UNITED STATES PATENT AND TRADEMARK OFFICE

APPLICATION NO.	FILING DATE	FIRST NAMED INVENTOR	ATTORNEY DOCKET NO.	CONFIRMATION NO.
10/707,044	11/17/2003	Richard M. Chesbrough	71202-0048	4171
20915 7590 02/27/2007 MCGARRY BAIR PC 171 MONROE AVENUE, N.W. SUITE 600 GRAND RAPIDS, MI 49503			EXAMINER SOLANKI, PARIKHA	
			ART UNIT	PAPER NUMBER
			3737	
SHORTENED STATUTORY PERIOD OF RESPONSE		MAIL DATE	DELIVERY MODE	
3 MONTHS		02/27/2007	PAPER

Office Action Summary

DETAILED ACTION

FIG. 9

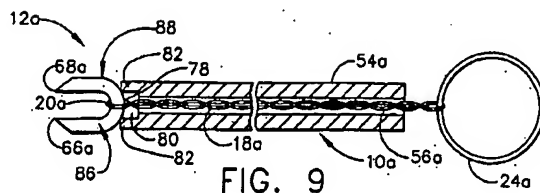
Regarding claims 1-4, 30-33, 35-37, 40, 46, 47, Foerster ('305) discloses means and steps for localizing a tissue mass via a device comprising a marker and a connector separably connected to the marker, wherein the connector may be unthreaded from the marker by pulling the connector (Figs. 9-11). The marker and connector of Foerster ('305) constitute an imaging element and a guide element, respectively, as claimed in the instant application. Foerster ('305) shows that, when the marker is placed within the tissue mass, the connector extends exteriorly of the tissue mass, and when the connector is separated from the marker, no part of the connector extends from the tissue mass (Figs. 10 & 11). Foerster ('305) states that the marker may be visualized via any state of the art imaging system (Abstract).

Regarding claims 14, 26, 55 and 62, Foerster ('305) shows that the connector is a filament (Figs. 9-11).

Regarding claims 3, 39 and 41, the breaking of the connector loop as shown by Foerster ('305) constitutes a cutting mechanism as claimed in the instant application (Figs. 9-11). Foerster ('305) also states that the connector is discarded after it is detached from the marker, which constitutes removing the cut portion of the guide element as claimed in the instant application (§ 0049).

FIG. 10

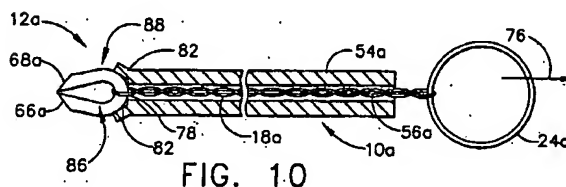
Regarding claims 19 and 58, the connector of Foerster ('305) is coupled to the marker by being threaded through the loop of the marker (Fig. 10).

FIG. 11

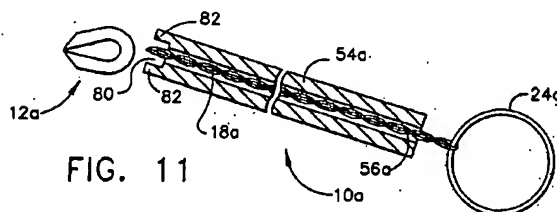
Regarding claim 18 and 57, Foerster ('305) discloses that the connector includes a failure point, at which the element may be separated from the marker after the marker has been placed in the tissue (§ 0020 & 0049, Fig. 11).

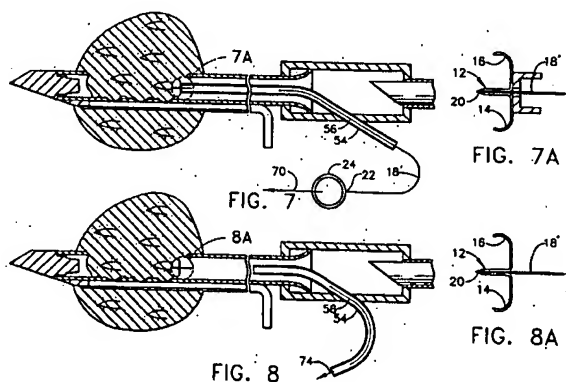
Regarding claims 23 and 66, Foerster ('305) provides a pull ring attachable to the guide element (Figs. 9-11, element 24a). The pull ring of Foerster ('305) is equivalent to a gripping element as claimed in the instant application.
